AIR RESOURCES BOARD

Executive Order G-70-33-A

Relating to the Modification of the Certification of the
Hirt VCS-200
Service Station Phase II Vapor Recovery System

Exhibit 1
Executive Order G-70-33-A
Hirt VCS-200 Phase II Vapor Recovery System

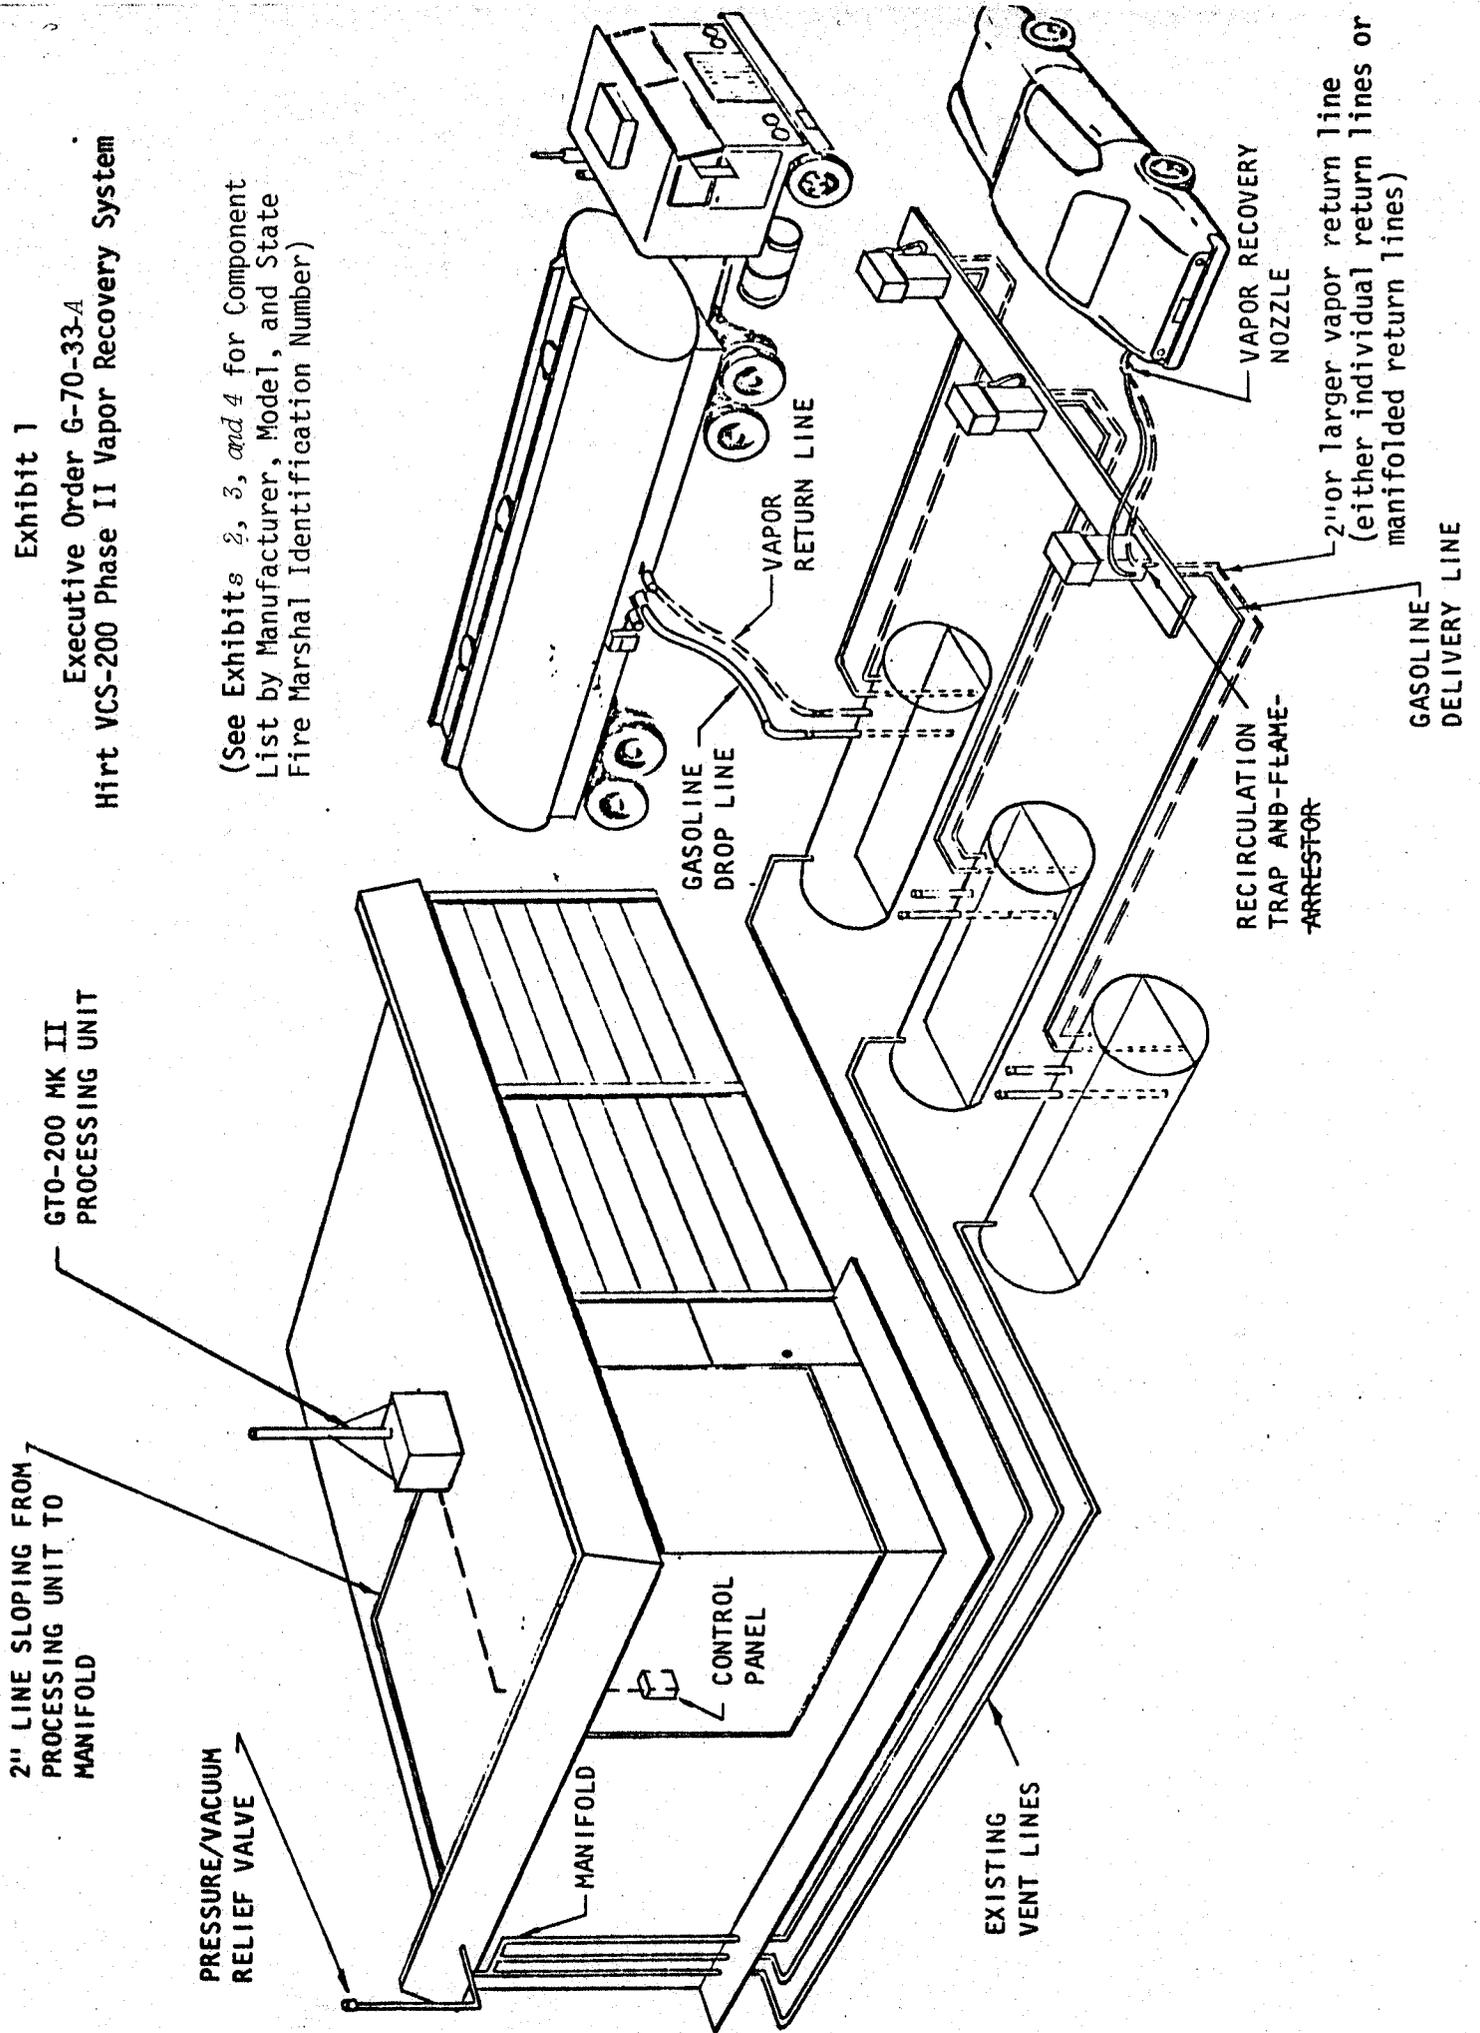
1. Include the OPW-7VE vapor recovery nozzle with Hazlett HC-2 ball check valve as an alternate nozzle;
2. To include the OPW-7VC vapor recovery nozzle as an alternate nozzle;
3. To include alternate high hose configurations, described in Exhibits 3 and 4;
4. To delete dispenser flame arrestor requirements;
5. To include an alternate pressure/vacuum relief valve; and
6. To eliminate the previously allowed use of a single OPW 78 series recirculation trap on dual dispensers dispensing the same product from both sides.

Hirt VCS-200 Service Station
Phase II Vapor Recovery System
Alternate Hose Configuration with OPW-7VE Nozzle

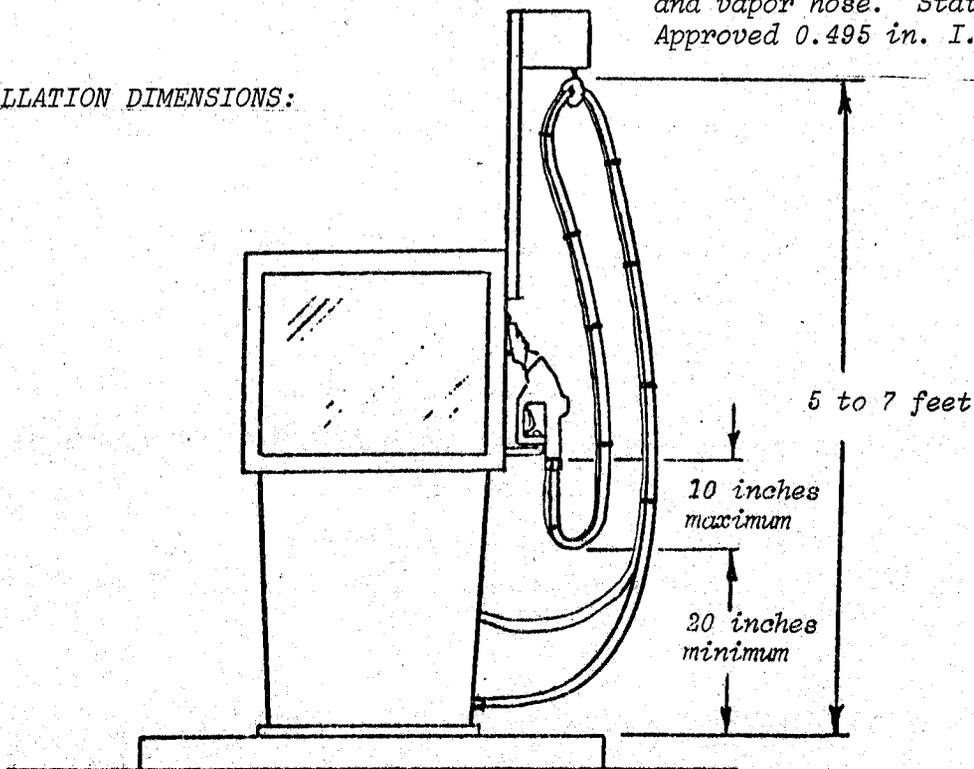
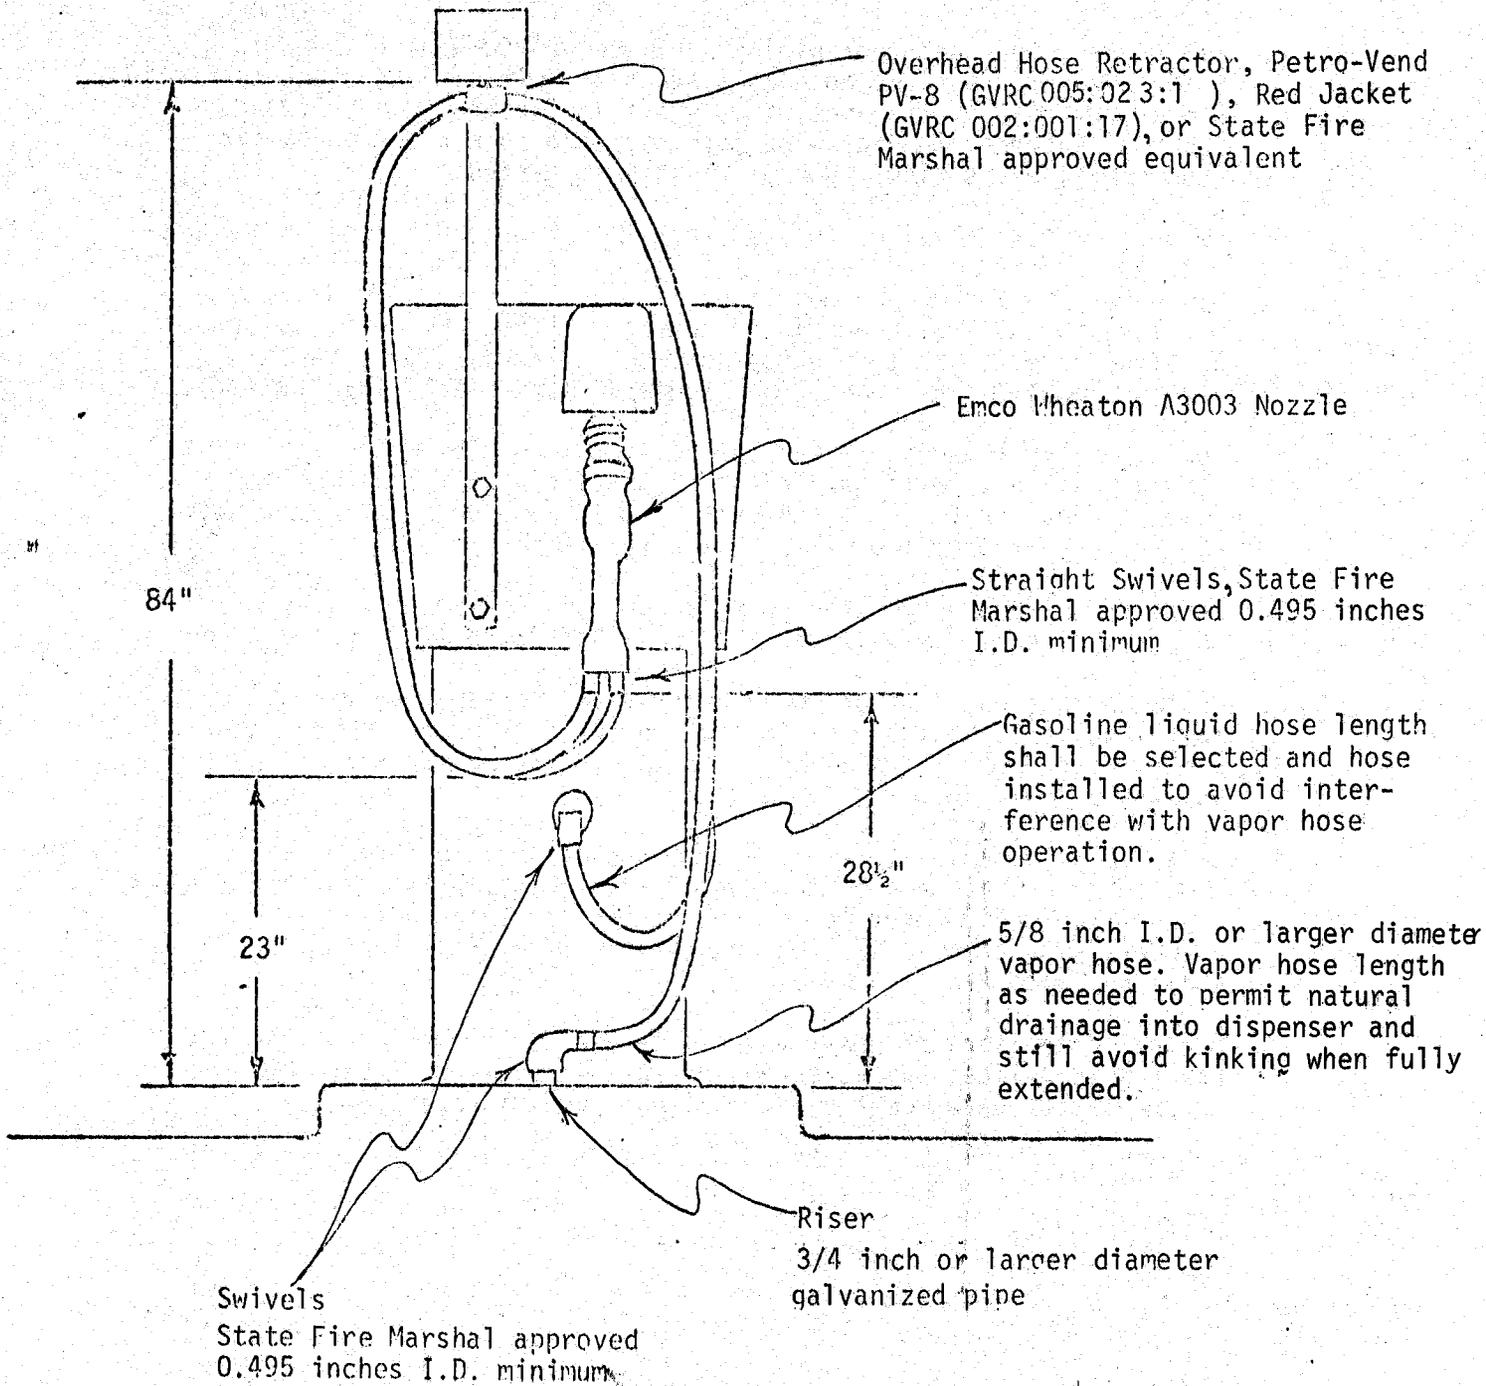
- NOZZLE: OPW-7VE
- BALL CHECK VALVE: Hazlett HC-2
- FLUID HOSE LENGTH: Fluid hose length shall be selected and hose installed to avoid interference with vapor hose operation.
- VAPOR HOSE LENGTH: As needed to permit natural drainage into dispenser and still avoid kinking when fully extended
- VAPOR HOSE DIAMETER: 5/8" inside diameter (8 gpm maximum dispensing rate)
3/4" inside diameter (12 gpm maximum dispensing rate)
- RETRACTOR: Petro Vend PV-8 (GVRC 005:023;1), Red Jacket (GVRC 002:001:17) or State Fire Marshal approved equivalent
- CABLE LENGTH: 10 Feet
- RECIRCULATION TRAP: None
- SWIVELS: 360° in-line on each end of both fluid and vapor hose. State Fire Marshal Approved 0.495 in. I.D. minimum
